AG-SB-2016-03-B-EN – Replacement Oil Pump Adaptor

This Service Bulletin is applicable for all Calidus, Cavalon and MTOsport.

A case was found during service of an overtightened adaptor leading to a breakage. This change introduces a part less likely to break in service.

Fig.1 Oil pressure switch

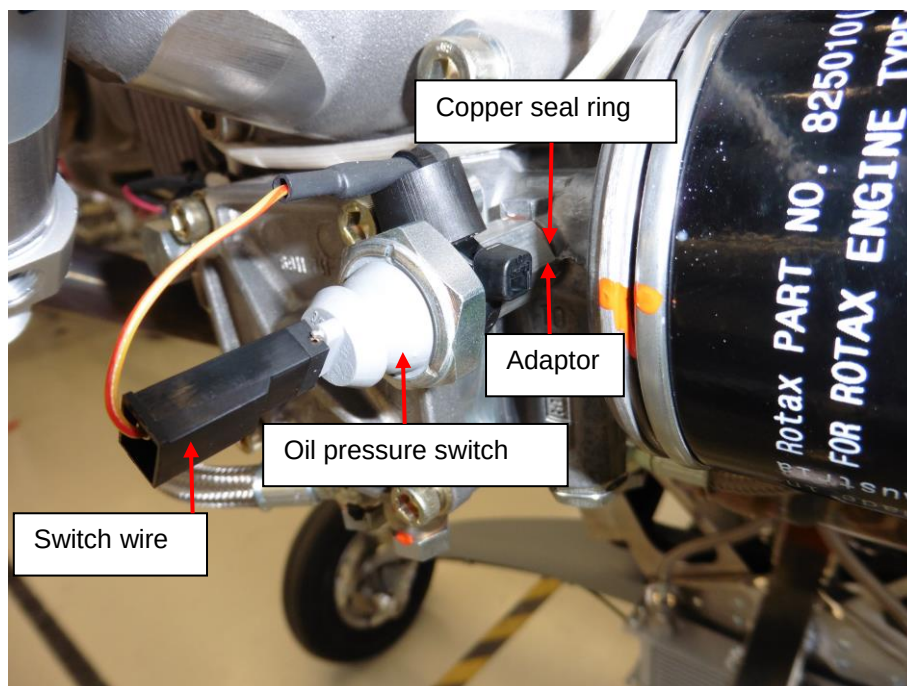
- Replacement of oil pump adaptor.

- 1 Remove the oil pressure switch connector (Fig.1).
- 2 Remove cable ties and spacer (Fig.1).
- 3 Remove the oil pressure switch, complete with the adaptor from the oil pump housing (Fig.1).
Caution: A small amount of oil will escape, be prepared to catch it!
- 4 Put the adaptor in a vice and unscrew the oil pressure switch. Clean the threads of the switch, the washer and the oil pump housing.
Note: Inspect the washer for possible damage!
- 5 Assemble and tighten the oil pressure switch, the washer to the new adaptor in a vice first. Apply Loctite 542 to the oil pressure switch (Fig.2).
- 6 Apply Loctite 542 to the adaptor and oil pump housing. Instal it with new copper seal ring and tighten it with a torque of 10 Nm.
- 7 Fix the cable with cable ties and spacer (Fig.1).
Effectivity: Calidus and Cavalon
- 8 Install engine cowlings, according to chapter 52-00-00 4-1.
Effectivity: End
